Communication from the City Plan and Zoning Commission advising that at their meeting held April 4, 2013, the following action was taken regarding a request from Hy-Vee, Inc. (lessee) represented by John Brehm (officer) to amend the Southgate C-4 Development Plan for property at 3221 Southeast 14<sup>th</sup> Street.

**APPROVAL** of Part B & C) to approve the proposed amendment to the Southgate "C-4" Development Plan and the submitted Site Plan subject to the following conditions:  
(ZON2013-00035 & 10-2013-7.89)

We have reviewed the first (1st) submittal of the site plan for the Hy-Vee Convenience Store SE 14<sup>th</sup> Street, located at 3215 SE 14th Street in Des Moines, and have determined that the following conditions must be satisfied before plan approval can be granted.

HyVee, Inc. - 3221 Southeast 14th Street

**DEVELOPMENT PLAN**  
 C1.01

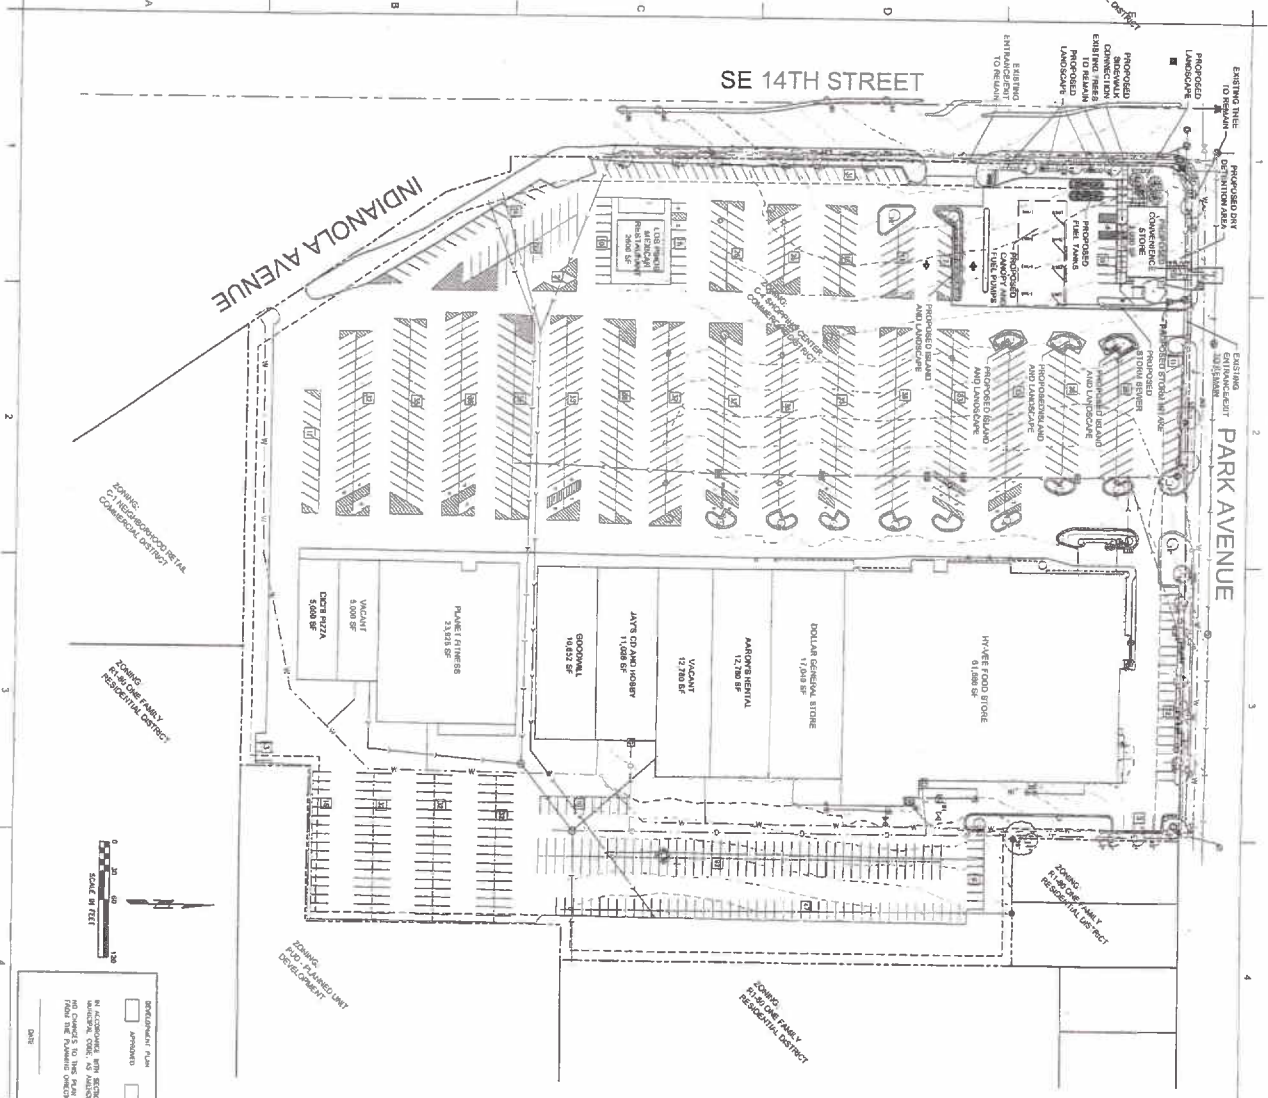
1. Show and identify the roof drainage outlet locations on the proposed building.
2. Show the size of the existing public sanitary sewer in E. Park Avenue.
3. Show and properly locate the existing public storm sewer easement at the north end of the site.
4. The proposed HDPE storm sewer pipe material from the canopy to the proposed area intake as well as from under the sidewalk will most likely not meet Plumbing Code. These pipes do not have to meet Plumbing Code if they can outlet to daylight in the basin since this would not be a direct connection to our public storm sewer system.
5. The 15-inch RCP storm sewer exiting the proposed area intake seems to be a bit oversized.
6. The certification statement on the storm water management plan must be signed and dated.
7. Reference the orifice plate detail from Sheet C5.01 on Sheet C3.01 by the INT1.1 flag note.

8. Detail 8/C5.02 appears to be mislabeled "OPEN-SIDED AREA INTAKE".

11. A project address of 3215 SE 14<sup>th</sup> Street has been assigned to this project. Show the project address on the site plan (ensure that all sheets with an address shown are corrected).

12. Add the "E" (east) prefix to the Park Avenue street name shown on the plan, as this portion of street is officially named E. Park Avenue.

13. The layout and landscape plans can be difficult to read with the gray scale existing site conditions layer shown. Is it possible to remove or change the scale or line weight of the existing conditions to make the plan less confusing?

14. Show the zoning of surrounding properties on the site plan or vicinity map.

15. Reference C-4 Development Plan amendment number ZON2013-00035 on the site plan.

16. Show site boundary dimensions on the site plan.

17. Note the minimum required building setbacks on the site plan.

18. Note the total building height on the site plan.

19. Dimension the proposed building and fuel canopy on the site plan. Show the sq. ft. of the proposed structure on the Sheet C1.01.

20. Dimension the proposed parking lot paving setback from SE 14<sup>th</sup> Street on the site plan.

21. Will an additional pole or monument sign be added to the site as a result of this development? A location of ground-mounted or pole sign was not found on the site plan.

22. The proposed fuel canopy appears to exceed the maximum height guideline listed in the Convenience Store Design Guidelines by 1' 6". Waiver of this guideline may be requested to the Plan and Zoning Commission.

24. It is noted that the applicant intends to seek a waiver of the required open space design guideline. Based on the number of fueling locations provided, a total of 16,000 sq. ft. of open space should be provided. Your calculations show a total of 10,783 sq. ft. for a deficiency of 5,217 sq. ft.

25. Indicate seasonal or outside merchandise and display areas on the site plan.

26. No additional light pole fixtures were indicated on the site plan, but if new pole light fixtures are proposed, show the location on the site plan. Provide a product cut-sheet detail on the site plan, and indicate the height of the pole. The fixtures shall not be taller than 20 ft. (including base).

28. Add additional shrub plantings around the north and east sides of the trash enclosure.

29. Add one additional overstory tree to the turf grass area NE of the building.
